DESIGN REVIEW BOARD OCTOBER 21, 2016

1. 09:00-09:50 **DRB 160067 Triad Medical Morris Rd**
review Site Plan and Landscape, cursory Elevations
Staff recommends approval with light poles not in tree islands, amenity area at old Mill site with mulched path, work with Staff for trees and other landscape on elevated parking deck.

DESIGN REVIEW BOARD MEETING SUMMARY MEETING OF SEPTEMBER 16, 2016

6. DRB 160058 Westside Daycare Westside @ Webb Bridge

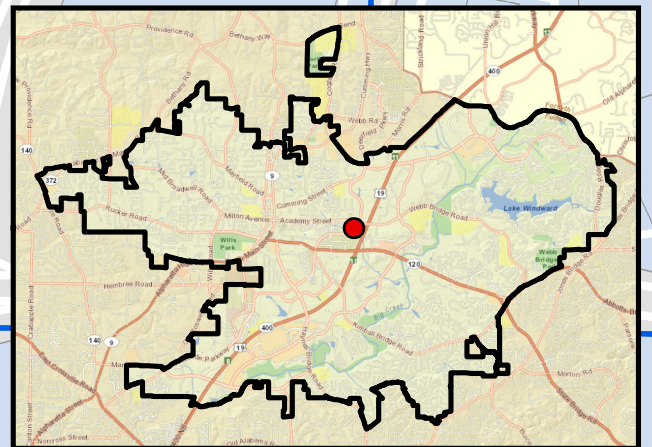
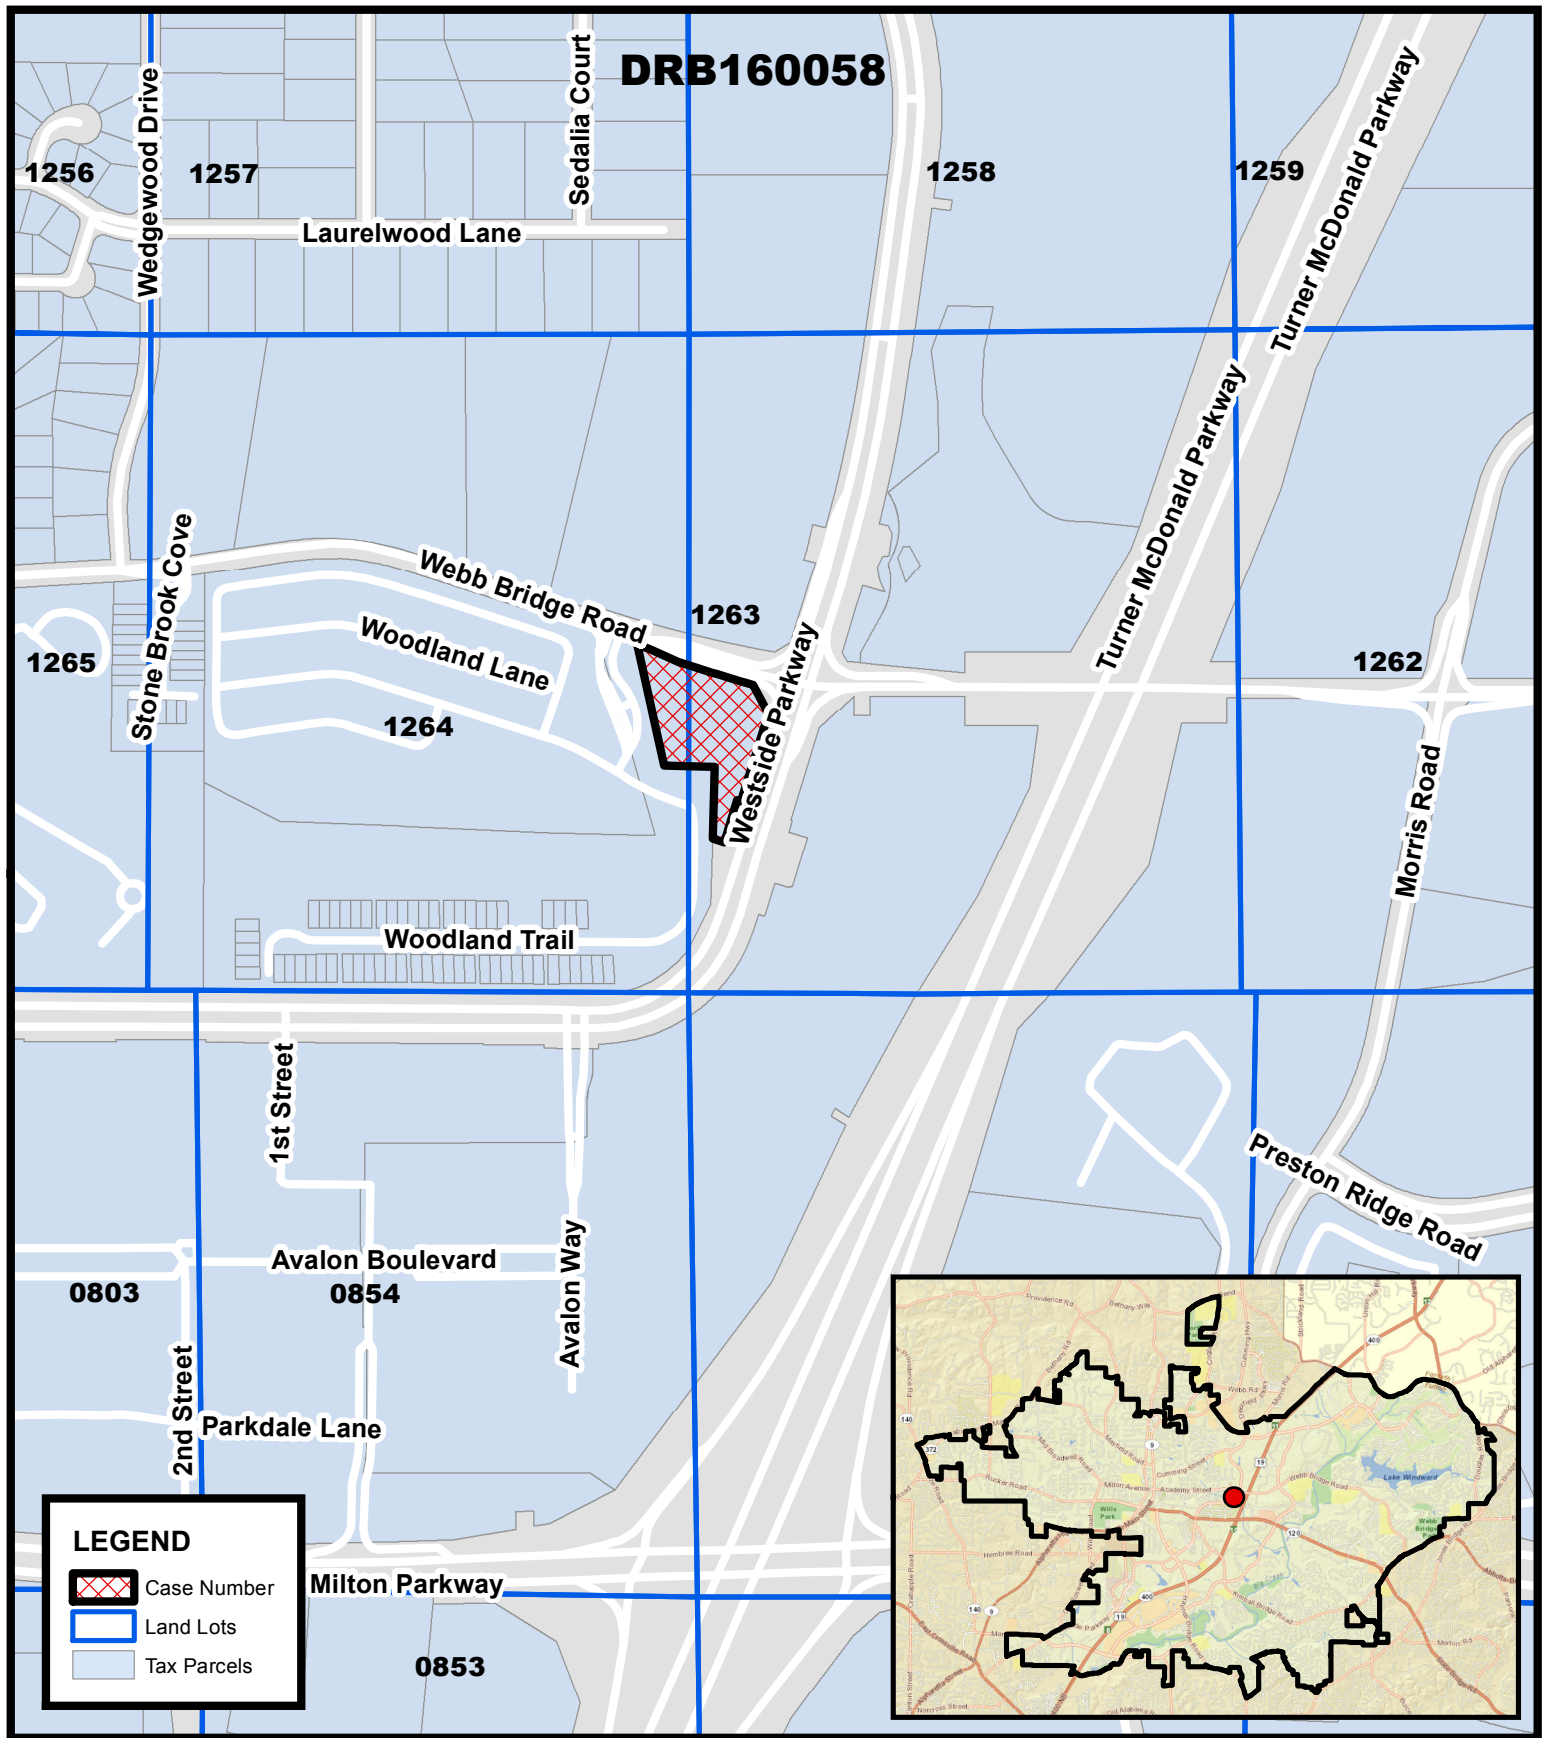
- Location of Entrances
- Location of Play Area
- Tree Saves
- Dogwood will not be saved due to grading issues
- Brick materials presented on sample board
- Hartiboard Accent on front
- Showed Photos of Location in Johns Creek
- Craftsman Style
- Percentages of materials on each elevation
- Visibility from Webb Bridge Rd
- Modular Wall

- Revised Site Plan directly addressing Westside Pky
- 50% Brick and/or Stone Condition
- Two types of Brick
- DRB did not like color of stone, too busy
Board Member Corkill commented on:

- 2 outside gables different materials on same elevation did not like
- Center gable needs to be taller
- Add Grids to Windows
- Two doors to the side on front entrance look more like fire doors. Materials need to match the front door.

- Discussed road grades due to large amount of roof
Board Member Brown agreed with everything Corkill said and suggested
- Stone is too busy, requested a more consistent stone or change to brick

- No walls facing the street, but will be visible from parking lot
- Dress up Gables on Window on far right
- Board did not like Window to the left of the front door (Heartiplank siding)

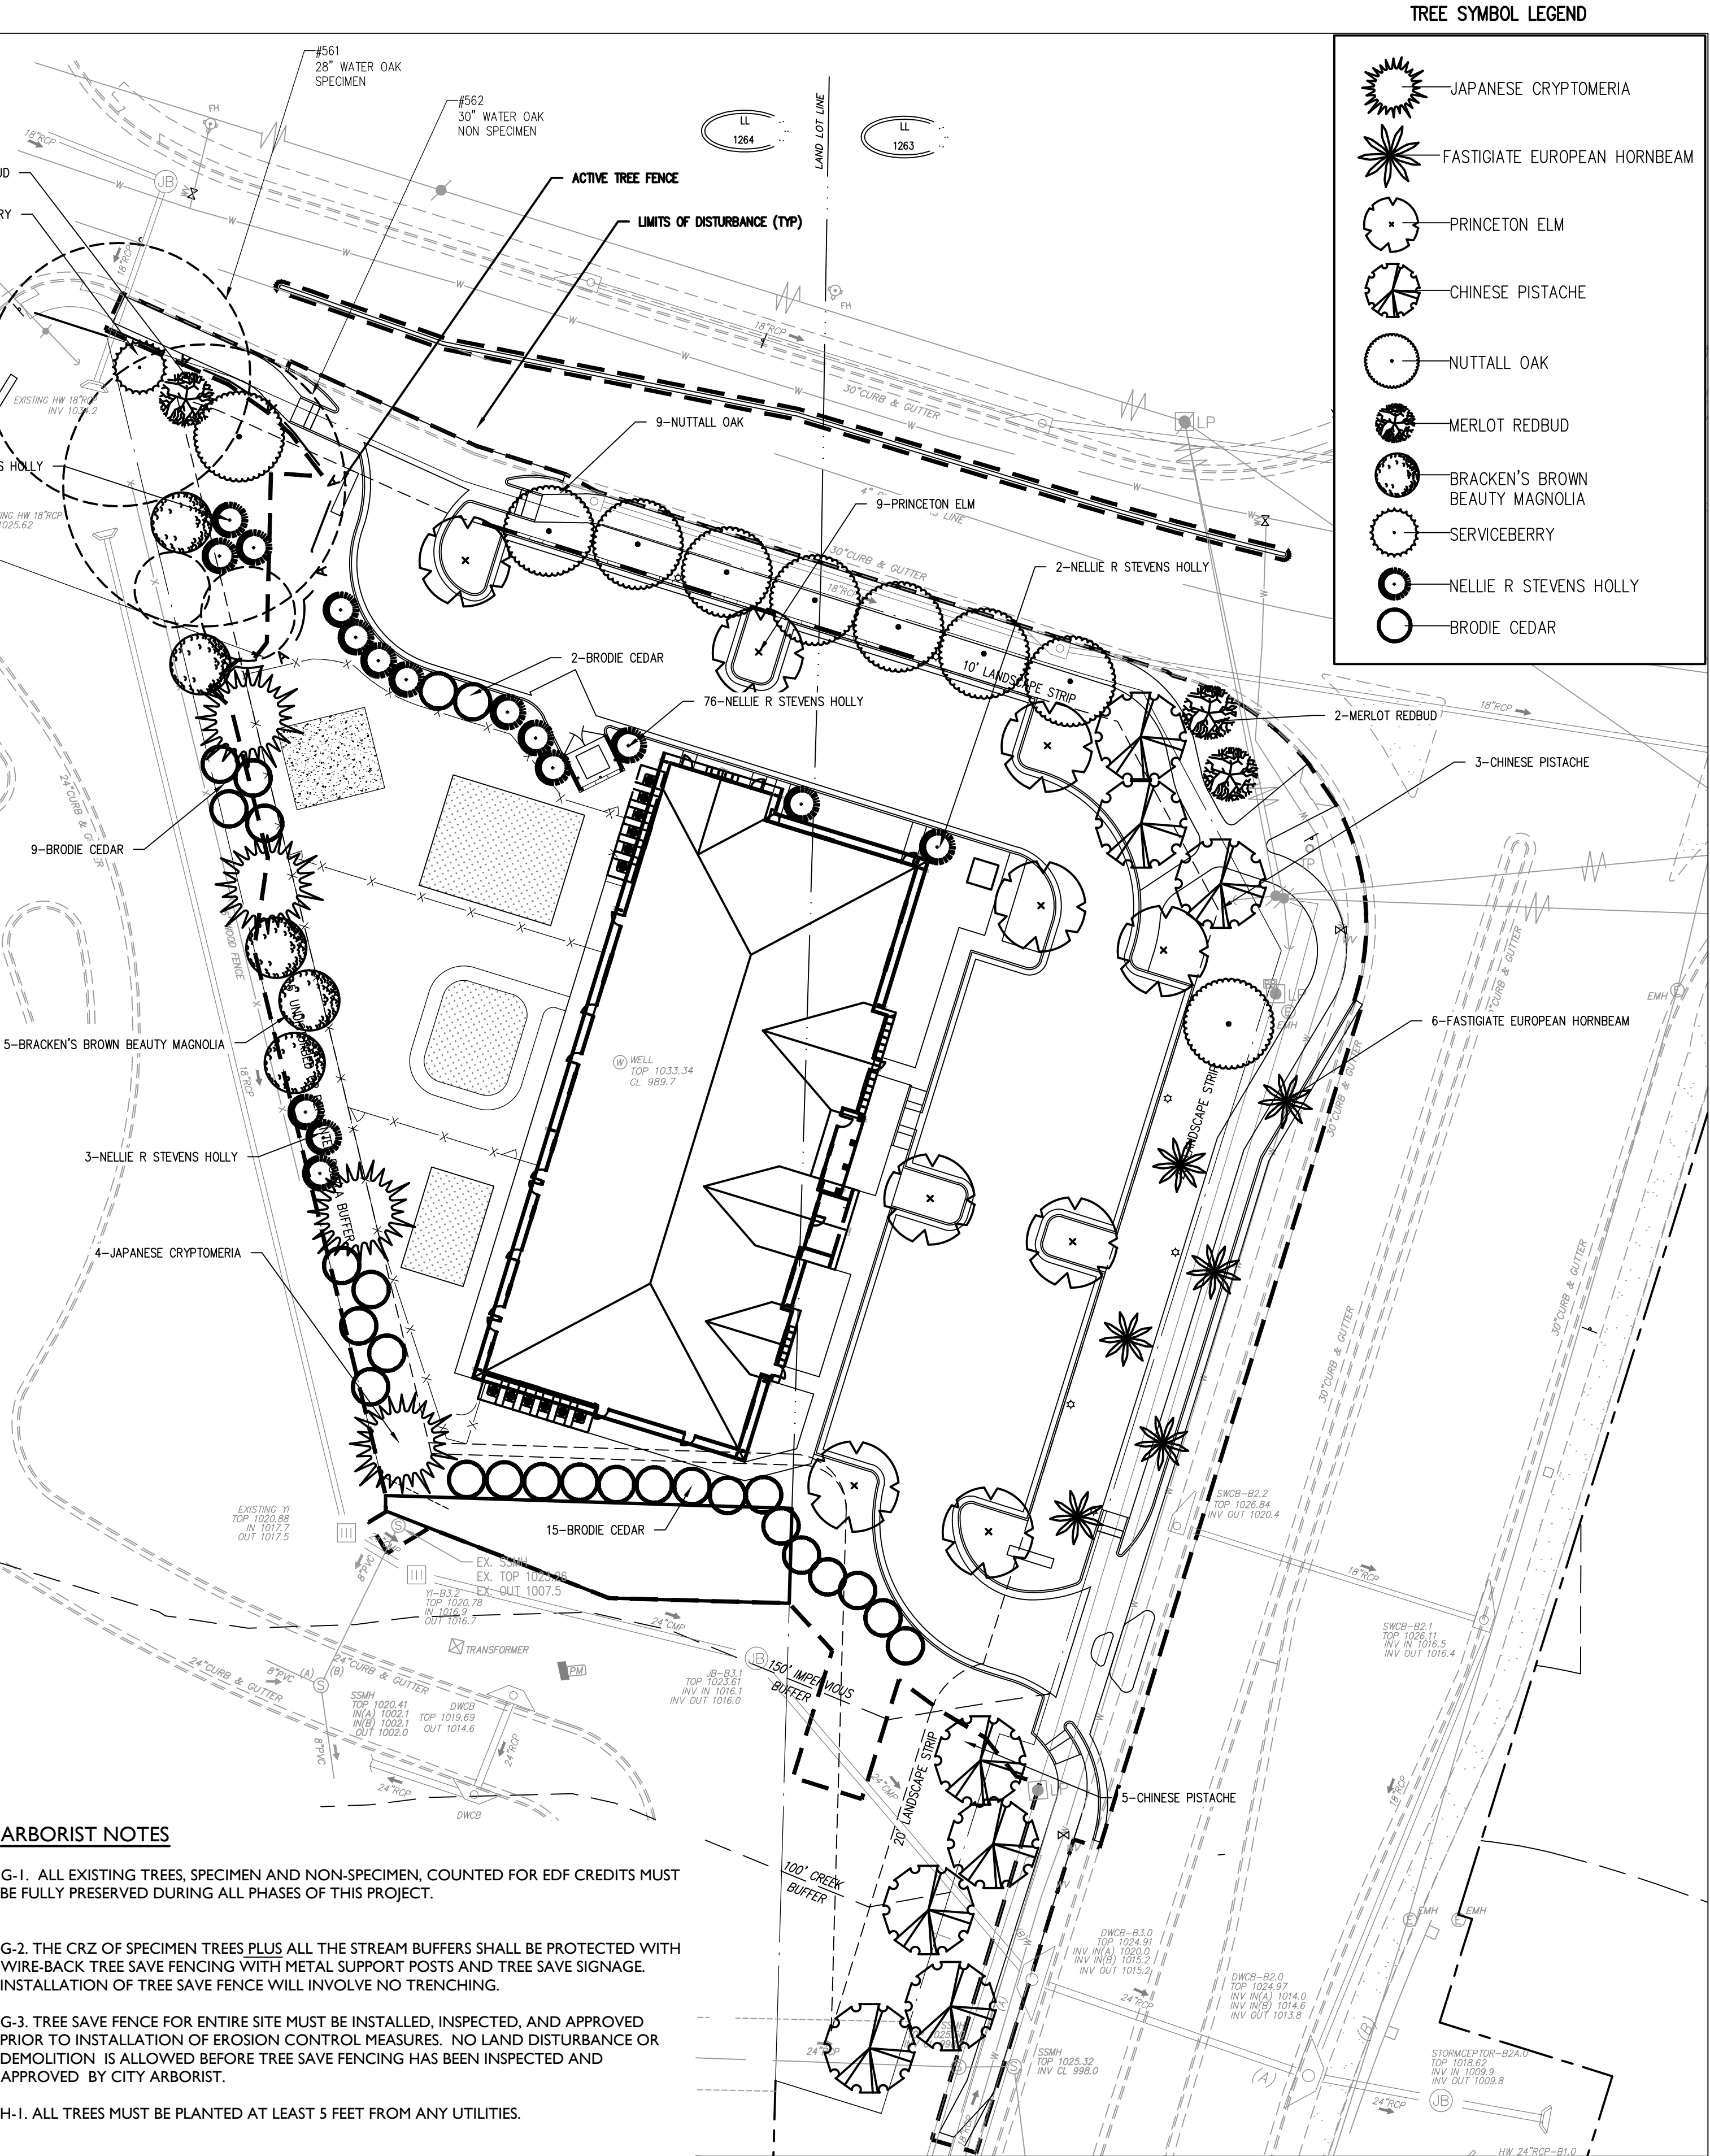
- We do not know what all of the proposed shrubs are along the ROWs. They will need to be evergreen and listed on the plant schedule as 2' tall and more than a 3 gallon size.

- Provide heights of evergreen trees and shrubs.
- Zoning Condition 5 has not been met. Add shrubs of varying heights, colors and textures. Tall enough and dense enough to screen any playground equipment.

- They will need to identify those existing trees and groupings to be saved per zoning condition 10. They will also need to show the areas to be replanted where sparse to meet this condition.

- • Double row of shrubs required between parking area and the ROW (min. 2' at planting). Only a single row is provided along Webb Bridge Rd.
- • Varying width (min. 15' in all areas) undisturbed buffer is required along all property lines adjacent to Woodlands at Webb Bridge. The buffer shall consist of evergreen material (trees and shrubs) of varying heights to create a vertical screen. There are areas that are not planted and no shrubs. Areas larger than 15' need planting throughout. Buffer shall meet the requirement of providing an opaque screen.

- • I'd recommend changing some of the selected shrub species. For example, get rid of the Knock Out Roses. I'd suggest using a variety of colors like loropetalum, boxwoods (variegated), lime light hydrangea, tea olives, wisteria, etc.
-

3. DRB 160064 Outback Steakhouse 6400 North Point Parkway

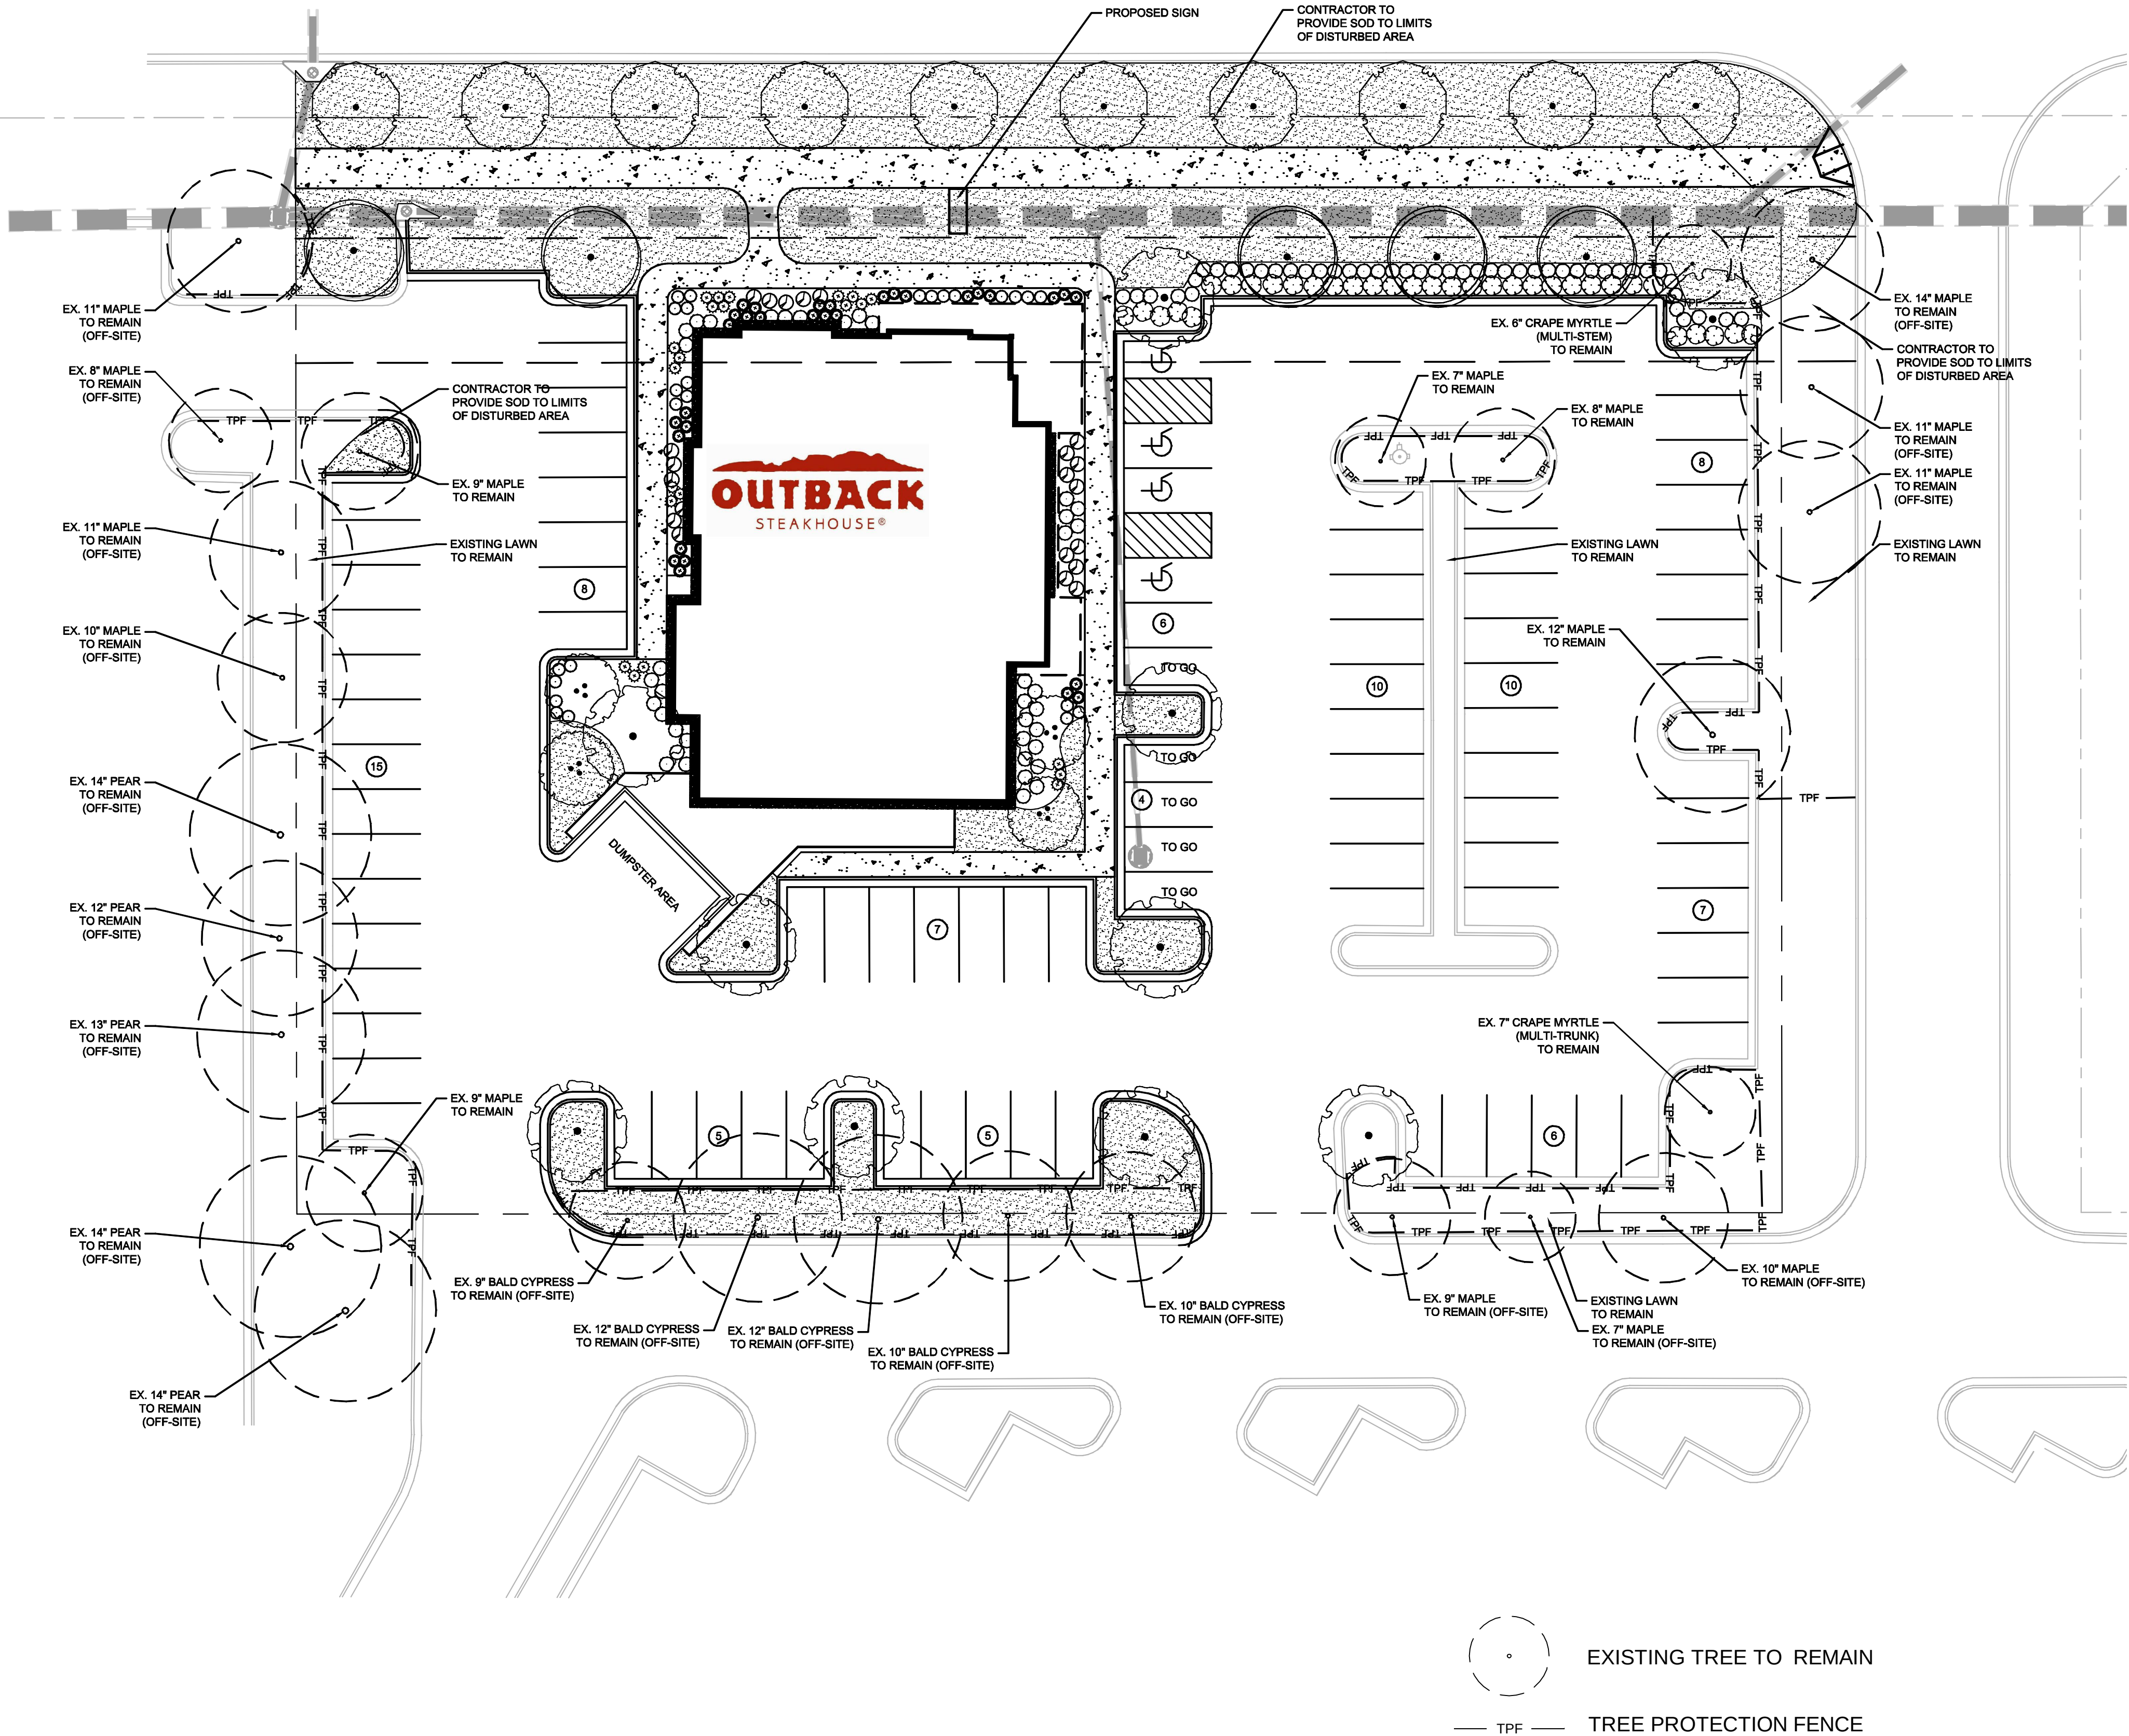
- Overview of Site Plan
- Screening of Parking
- Number of parking spaces
- Covered Area for seating for waiting
- Dumpster Enclosure
- Site Lines
- Potential for Outdoor Seating
- Site subject to North Point Activity Center Guidelines
- Formal and natural greenspace areas
- Pedestrian street lights along North Point Pky
- Internal sidewalks at key location should be paver materials
- Upgrade to NP Activity Center streetscape (as approved by Staff)
- Code pertaining to parking island
